SUBJECT: U.S. NUCLEAR REGULATORY COMMISSION ONSITE OBSERVATION  
REPORT FOR THE IDAHO NATIONAL LABORATORY IDAHO NUCLEAR  
TECHNOLOGY AND ENGINEERING CENTER TANK FARM FACILITY

**IDAHO NATIONAL LABORATORY IDAHO NUCLEAR TECHNOLOGY AND ENGINEERING  
CENTER TANK FARM FACILITY  
U.S. NUCLEAR REGULATORY COMMISSION ONSITE OBSERVATION REPORT**

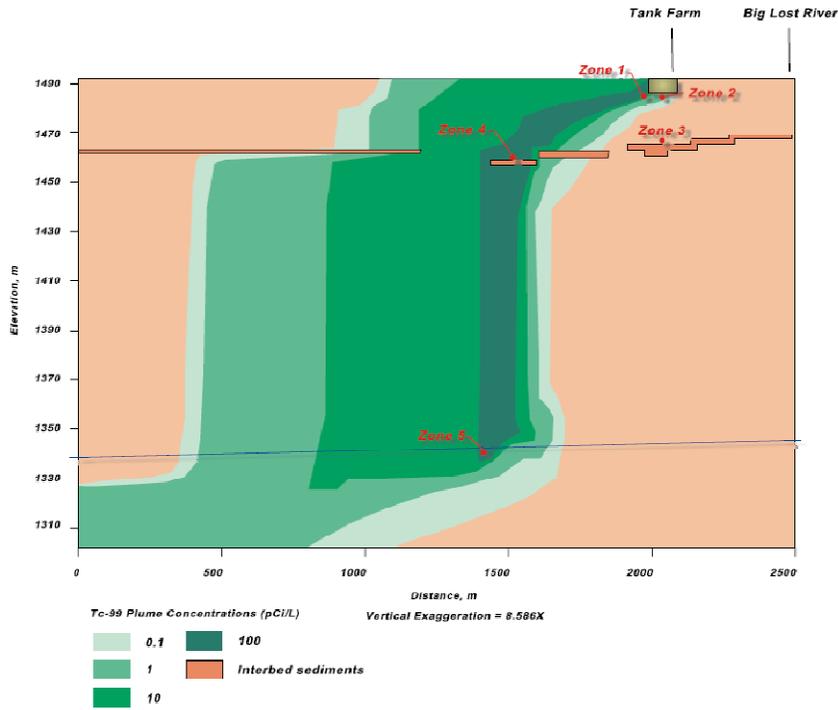
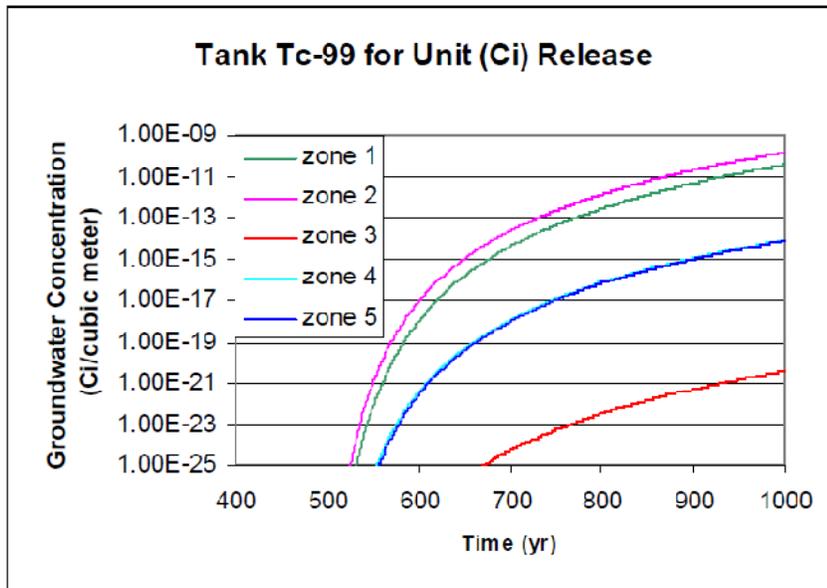
The data presented by DOE is consistent with NRC staff's understanding of the recently revised hydrogeological conceptual model of the INTEC TFF based on its review of monitoring and modeling activities conducted under the CERCLA program. However, as documented in NRC staff's TER and monitoring reports (NRC, 2006; NRC, 2008; and NRC, 2009), the monitoring results appear to be inconsistent with DOE PA modeling (DOE Idaho, 2003) predictions that show a very large impact of BLR flow on contaminant flow and transport of future TFF releases. As stated in a response to a follow-up Request for Additional Information (RAI) (DOE Idaho, 2006a), the large lateral extent of the modeled contaminant plume diverted laterally approximately 600 meters to the south of the TFF (see Figure 1 below) is due completely to the pressure gradient that results from the steady-state infiltration boundary condition for the BLR. In this response, DOE goes on to state that the large lateral extent of the contaminant plume is not indicative of perched water. As documented in NRC staff's TER (NRC, 2006), DOE's response to NRC's inquiry regarding the cause of the large lateral spread (DOE Idaho, 2006a) appears inconsistent with explanations provided in the actual PA documentation itself (DOE Idaho, 2003)—DOE's PA indicates that the numerical model predicts contaminant transport around the perched zones and through breaks in the interbeds. In fact, the numerical model results show no perched zones along or near the flow path of the contaminant plume as described in the PA making the relevance of the statement regarding perched water unclear. Additionally, there is no indication from the monitoring data that when BLR flow does occur that contamination could be deflected nearly half a mile laterally to the south of the TFF. Due to the uncertainties in the PA modeling predictions and due to the large amount of credit that appears to have been given to vadose zone performance in DOE's PA model with respect to dilution (approximately four orders of magnitude or a factor of 10,000 as shown in Figure 2 below [see difference in peak concentrations between zones 1 and 2 at the source and zone 4 at the vadose zone "spill-way" provided in DOE, 2006b]), NRC staff continues to recommend that DOE consider new and significant information collected under the CERCLA program in decisions to update its PA or in any future updates to its PA. Additionally, vadose zone transport mechanisms are important as they impact remediation and monitoring. For example, if this phenomena (i.e., large lateral deflection of INTEC TFF releases due to BLR imposed pressure gradients) actually occurs at INTEC or were to occur in the future, it could complicate remediation and monitoring of historical releases or monitoring of future releases that may occur from the INTEC TFF.

In fact, DOE indicated that it is in the process of determining whether its PA model needs to be updated. Given the risk significance of the groundwater model and additional CERCLA data that has come to light since development of the PA, NRC staff specifically recommended that DOE update its PA documentation (through an errata sheet or other textual revision) to clarify the cause of the lateral spreading of the contaminant plume and its risk significance as documented in responses to NRC RAIs (see DOE Idaho, 2006a and DOE Idaho, 2006b). NRC staff also recommended that DOE consider data and modeling conducted under the CERCLA program that has resulted in a revised hydrogeological conceptual model for the INTEC in determining whether to conduct additional modeling in an update to its PA.

NRC and DOE staff discussed monitoring conducted under the CERCLA program for the INTEC facility. NRC staff made two recommendations for DOE to consider in its decision to update the PA. NRC staff recommended that the PA reflect the results of simulations performed and additional documentation generated during the NDAA consultation process to answer NRC staff inquiry regarding the cause and performance impact of the significant lateral spread of the contaminant plume emanating from the TFF to the south (e.g., caused by pressure gradient from BLR seepage and resulted in up to a factor of 10,000 decrease in contaminant concentrations emanating from the tank farm facility for relatively mobile [non-sorbing] constituents such as Tc-99 and I-129). NRC staff also recommended that DOE consider (in its decision to update the PA) recent data collected under the CERCLA program that appears to be inconsistent with the DOE PA modeling results with respect to the impact of BLR flow on contaminant fate and transport at the INTEC TFF. NRC staff recommends that DOE should consider the new information in the next update to its PA maintenance plan.
